BARBUR BOULEVARD ROAD SAFETY AUDIT

SW Capitol Highway to SW Naito Parkway

October 2015

Road Safety Audit Report

Exhibit 84. Option #6 cross-section with reversible center travel lane

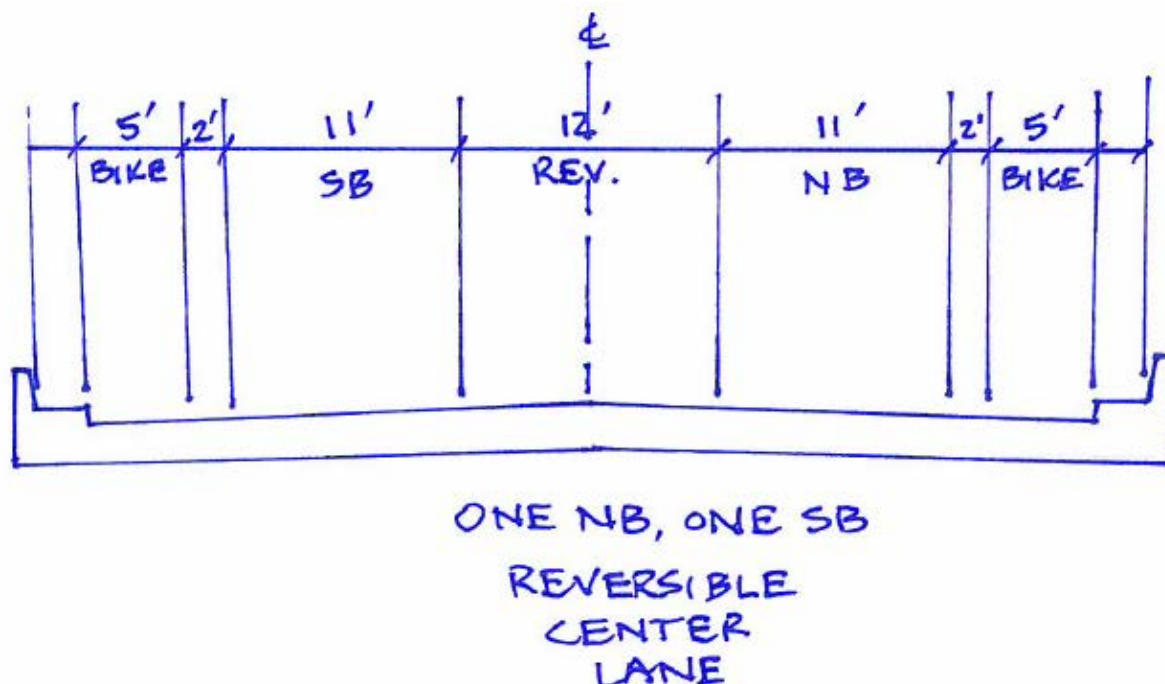
This option modifies the existing cross-section by restriping within the existing pavement width to introduce buffered bicycle lanes and to reduce the number of lanes on the bridge to three travel lanes, as shown in Exhibit 84. This option creates a reversible lane to serve the peak direction when needed. Overhead variable signage consistent with the MUTCD will be required.

Exhibit 85. Option #7 cross-section with single travel lane in each direction and protected bicycle lanes

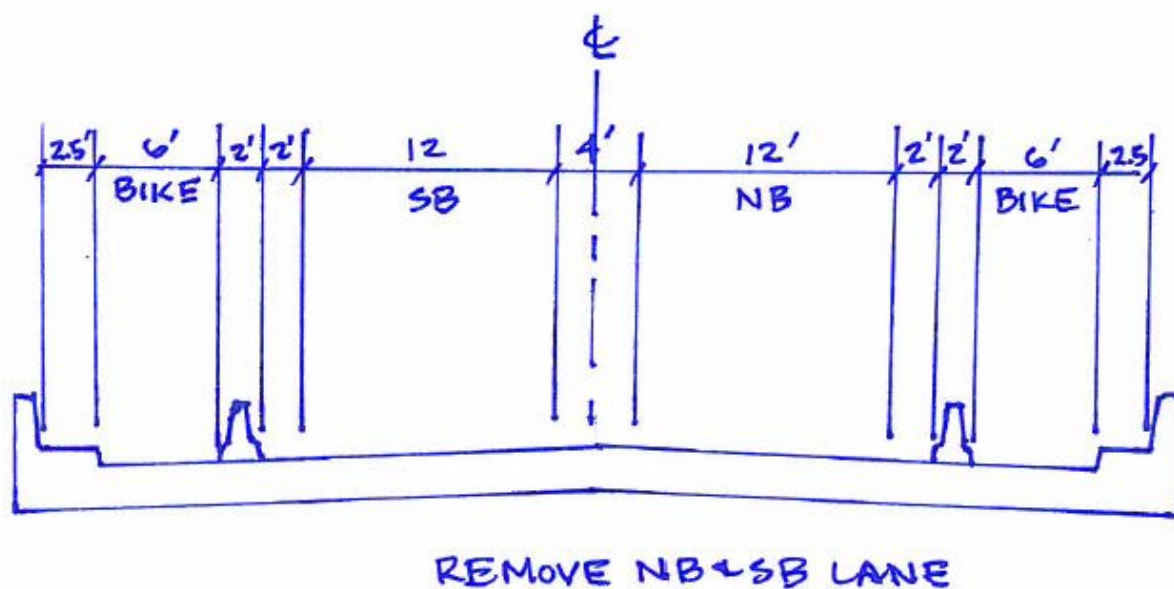
This option modifies the existing cross-section by restriping within the existing pavement width to introduce protected bicycle lanes and to reduce the number of lanes on the bridge to two travel lanes, as shown in Exhibit 85. This option assumes one of the northbound lanes is merged and the southbound outside lane is dropped prior to the bridges, which influences traffic operations in both directions on Barbur Boulevard. This option provides the greatest degree of separation for bicyclists, but it may create unacceptable diversions and operational issues from a wider transportation system perspective. Also, while this option provides enhanced bicycle facilities across the bridges, these conditions are not provided on the remainder of the corridor.
